NorthConnex Feedback Form

SUBMISSION ON EIS

9 SEPTEMBER 2014

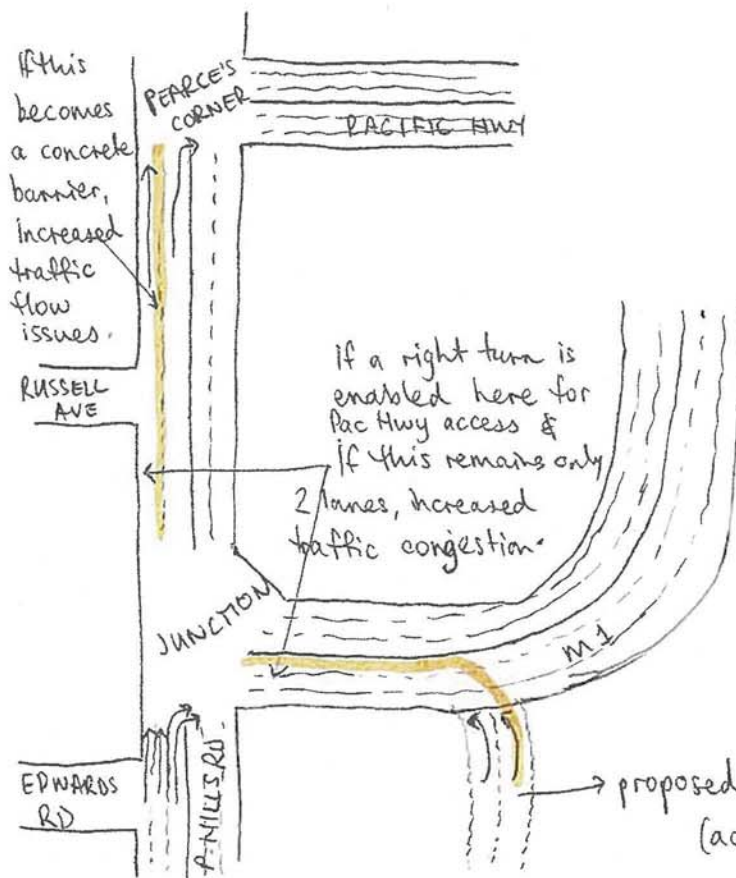
- * Currently, P. Hills Rd is 4 lanes at Junction (2 for M1 access, 2 for H'by direction)
 - * Currently, no turn right at Junction for northbound traffic
 - * Traffic heavily congested. Increased use of tunnel will further impede traffic flow at this junction.
 - * P. Hills Rd between Junction & Pearce's Corner only 2 lanes. One must turn right for Pac Hwy.
- proposed tunnel design/entry to P. Hills Rd.
(access to P. Hills Rd)
